MCW Consultants Ltd.

Addendum

Project Name: AQUAVISTA - Bayside
Client: TRIDEL Corporation
To: TRIDEL Corporation
Attention: Chadi Loza
Fax number: -

Title: Various Electrical Changes.

13 CCU ROOMS & BEANFIELD ENTRANCE ROOM - LEVEL P2
1:50

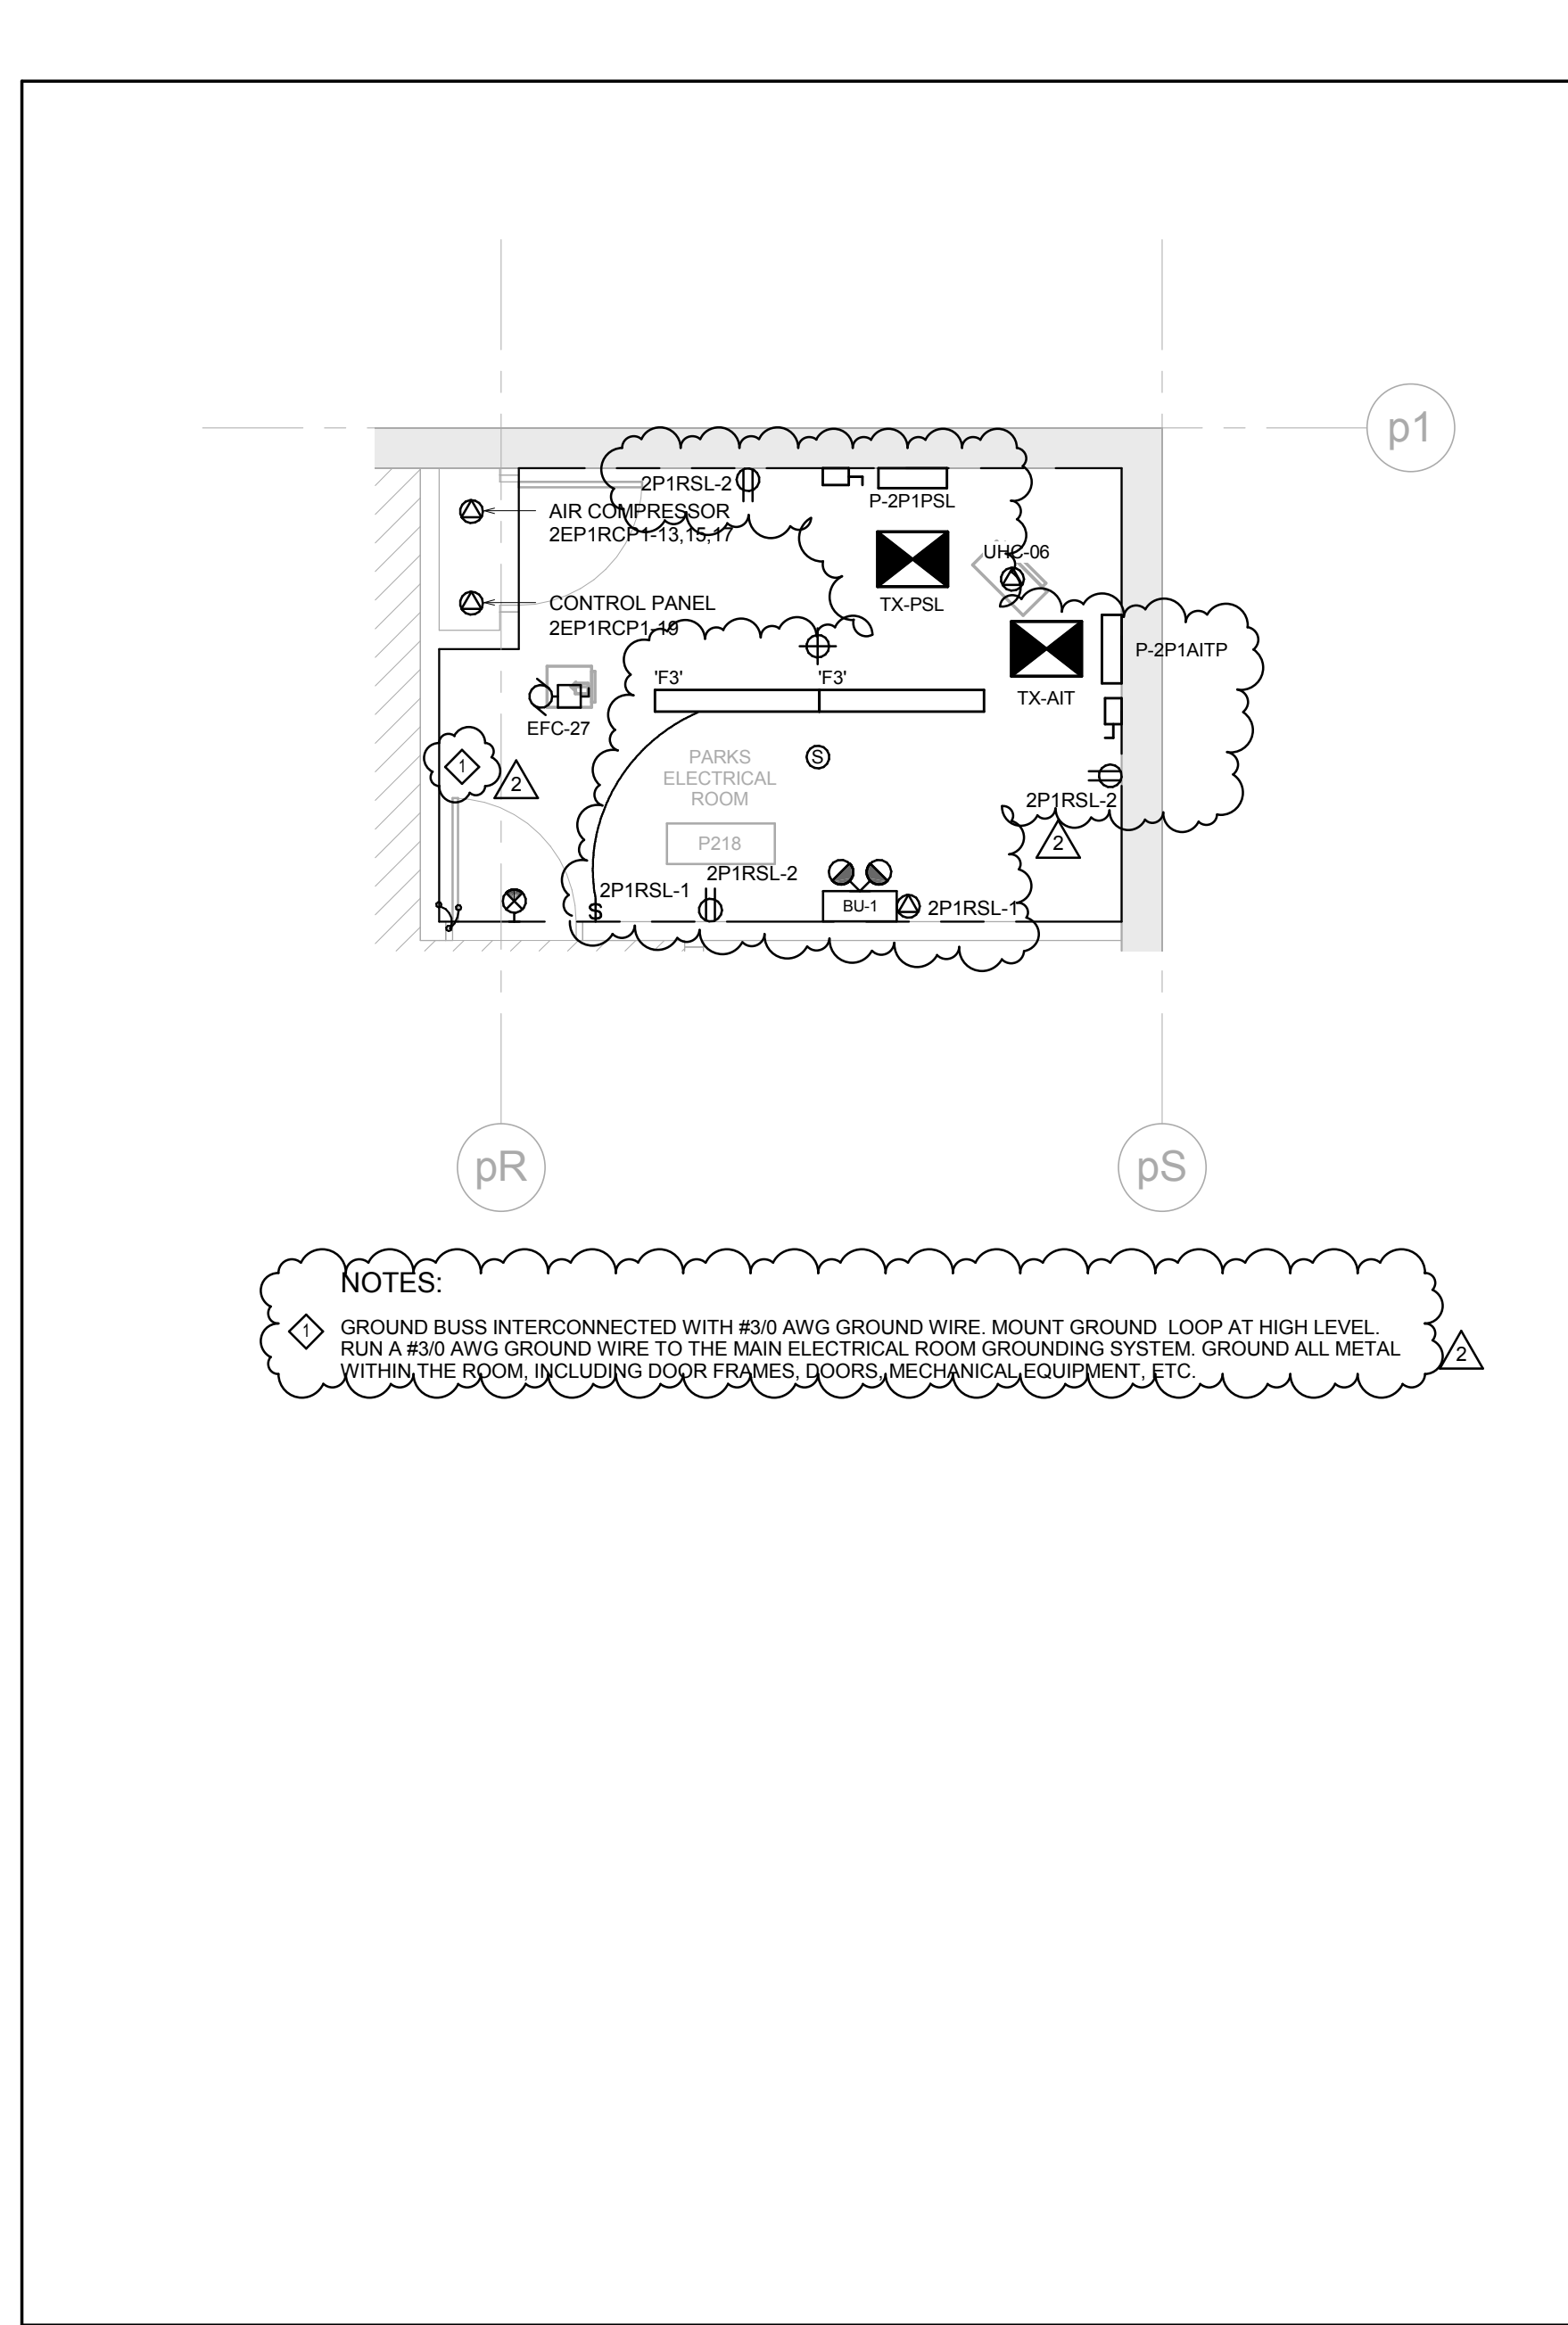
E3-01-RC	Yes	Distribution riser has been updated showing the correct location of panel 'P-2EP1RCP3'.
E4-03	Yes	Add remote fire alarm annunciator on retail fire alarm raiser as shown.
E4-04	Yes	Add fire alarm zones as shown.
E4-05	Yes	- Revise communication panel circuit number as shown. - Revise communication riser as shown.
E5-01	Yes	- Park electrical room layout has been updated. - Add emergency lighting battery unit in park electrical room as shown. - Add fire alarm smoke detectors and speaks to east electrical room and commercial room as shown. - Relocate panel 'P-2EP1RCP3' from main electrical room to east electrical room as shown. - Relocate panel 'P-2COMM' from main electrical room to lofty CCU room as shown. - Add new detail drawing for CCU rooms and Beanfiled entrance room as shown.

ME-15

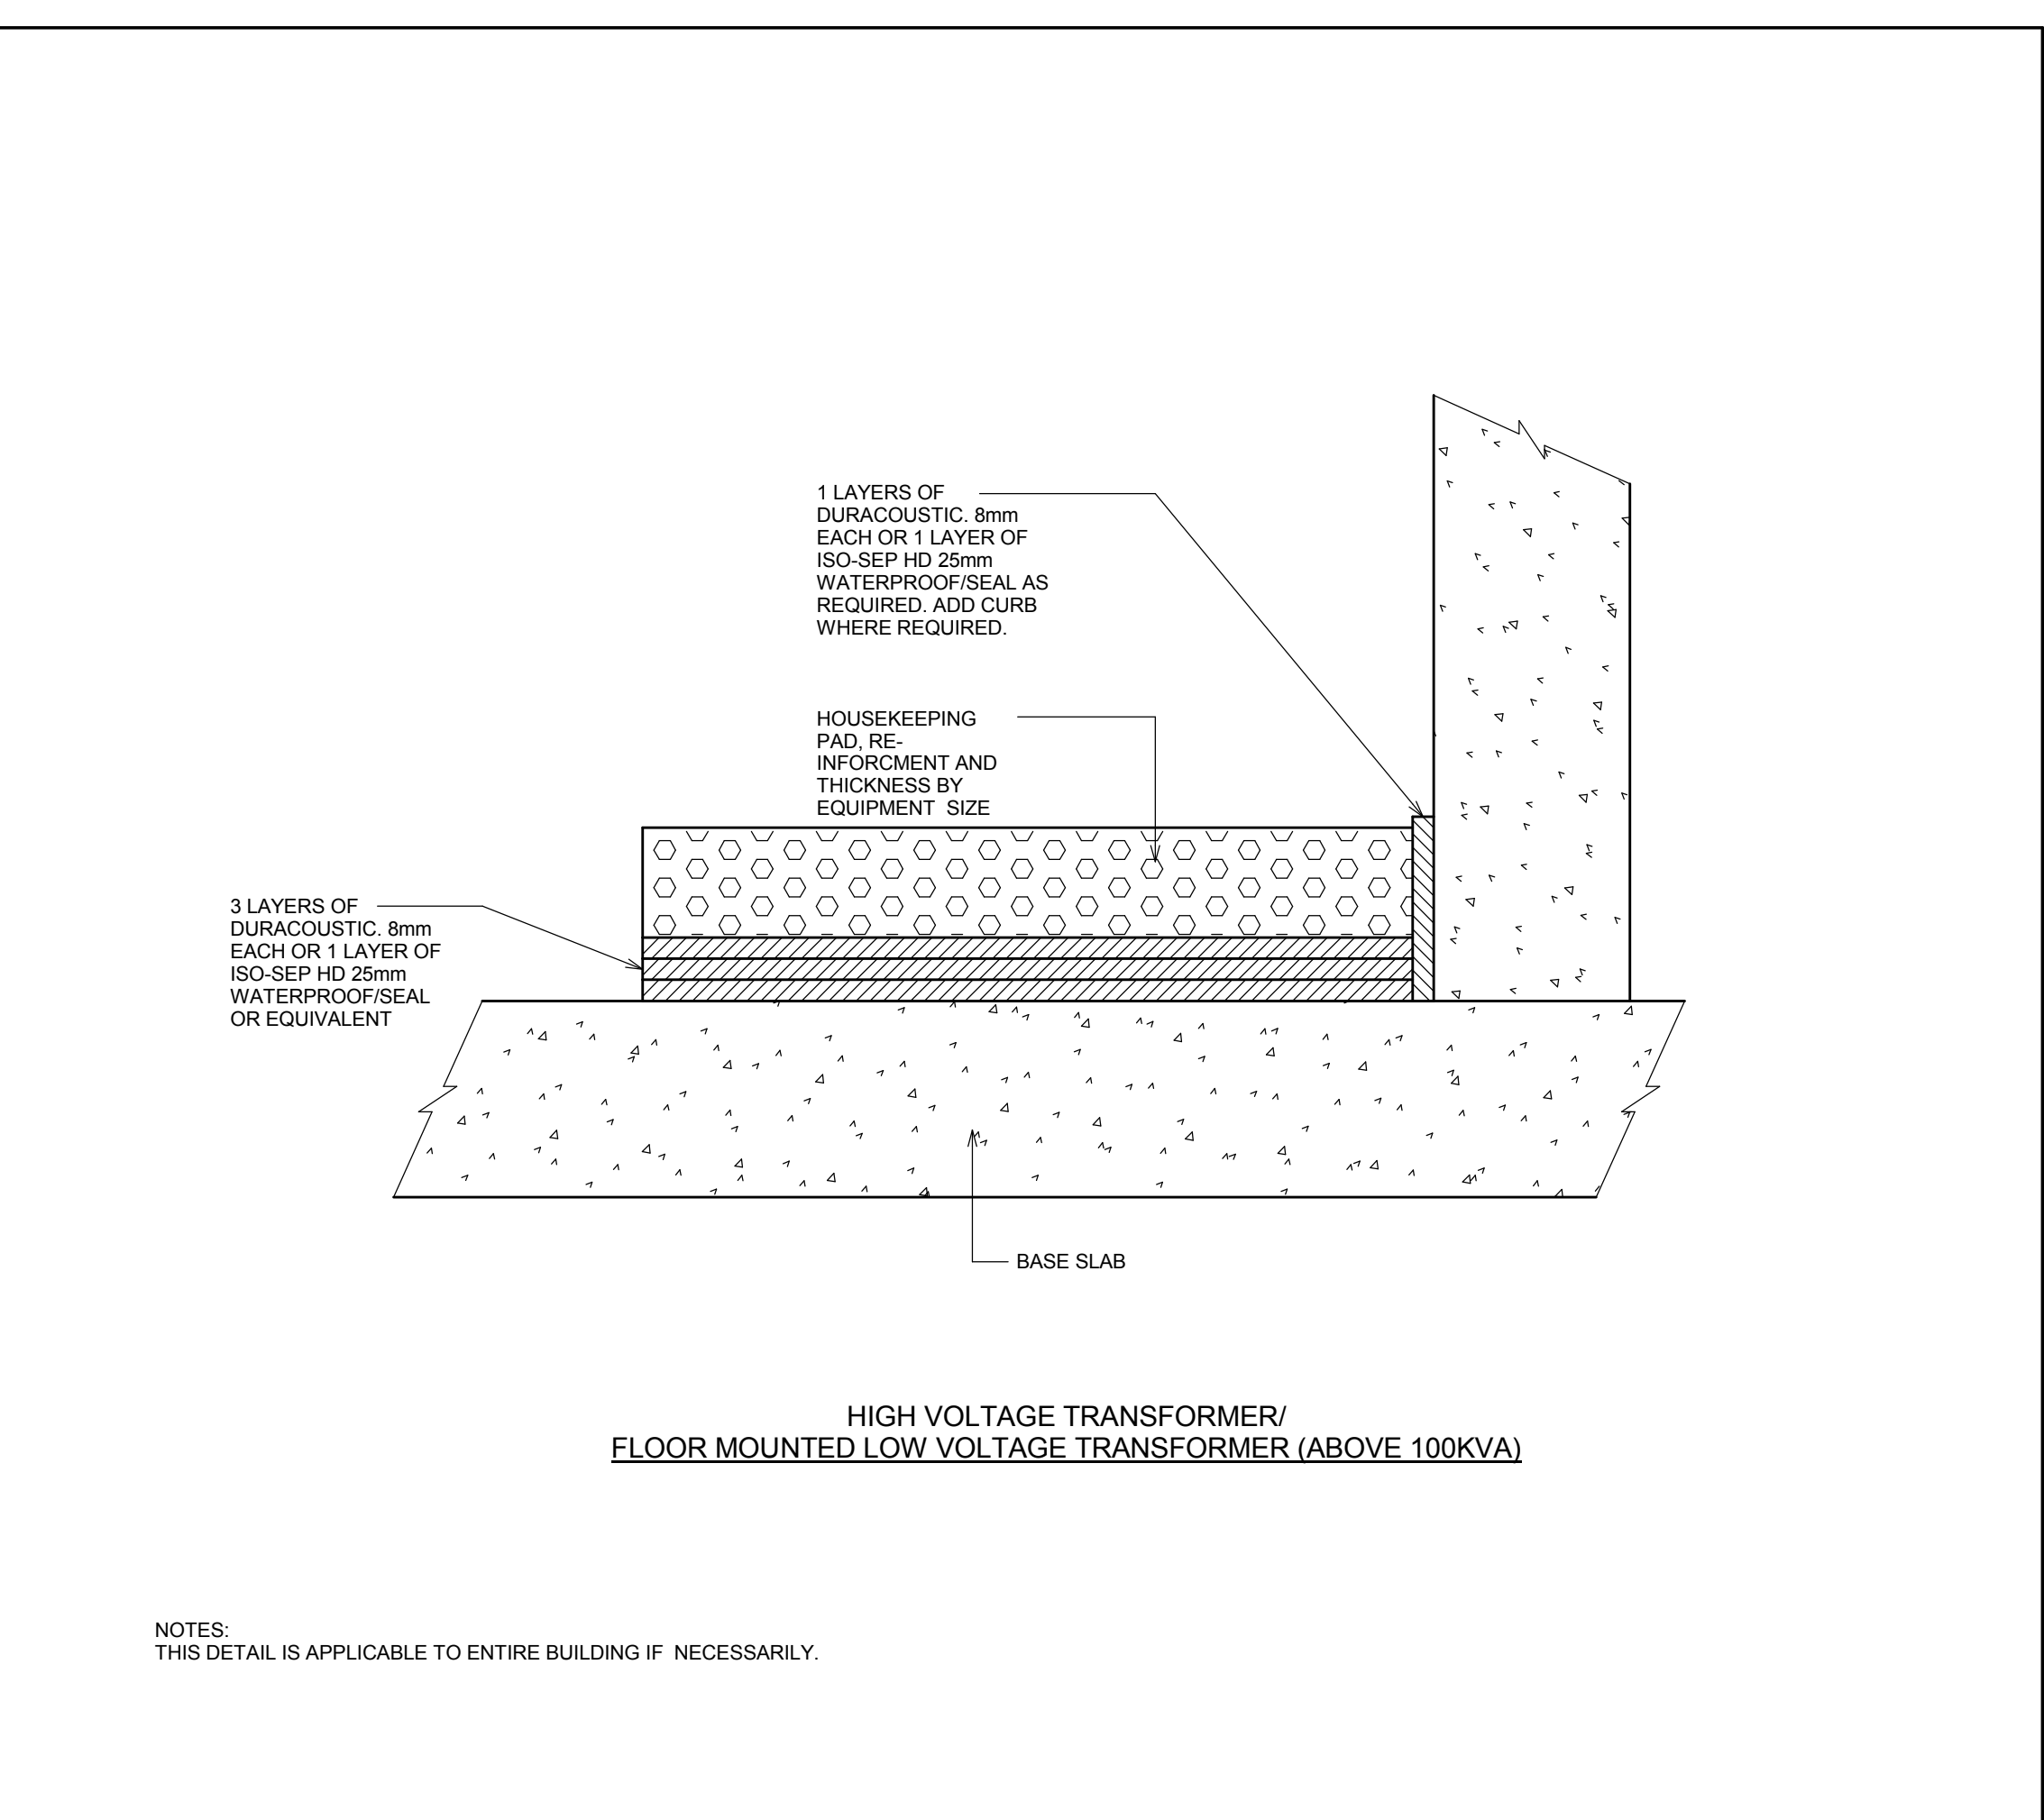
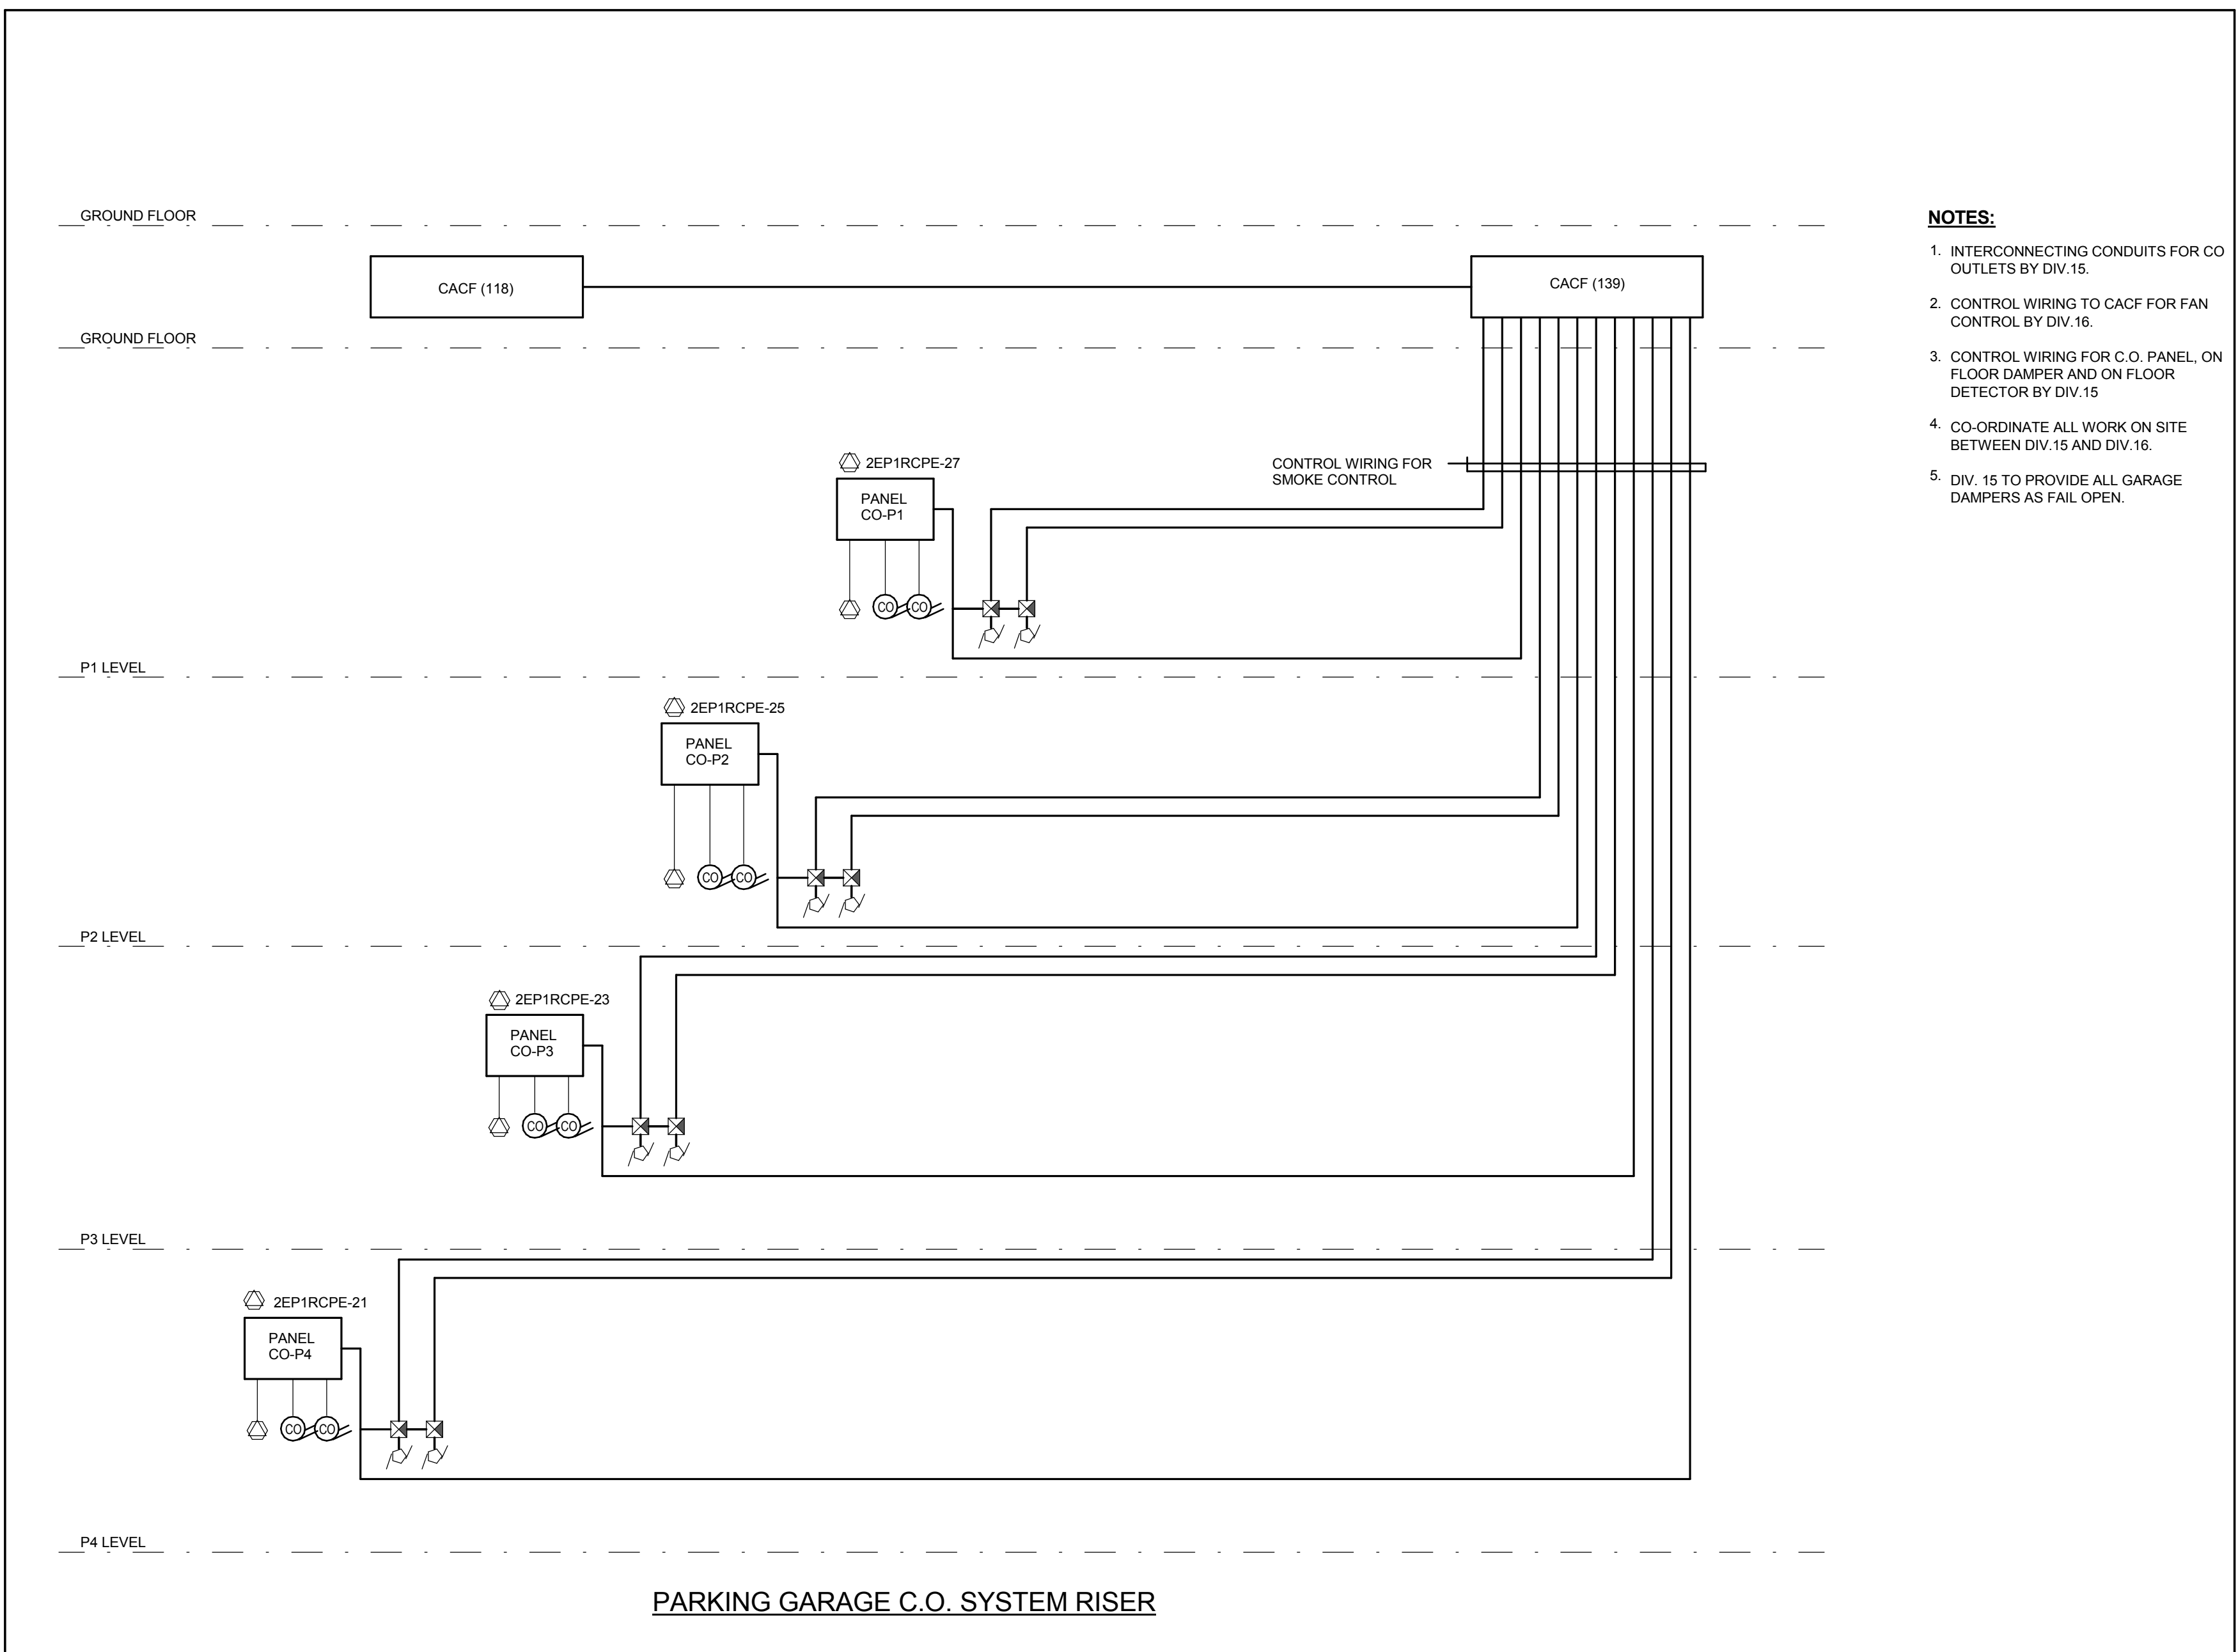
Drawing No.	Drawing Issued	Items
ME-15	Yes	Update ME schedule as shown. Contractor to coordinate with mechanical drawings for the exact location of the units.
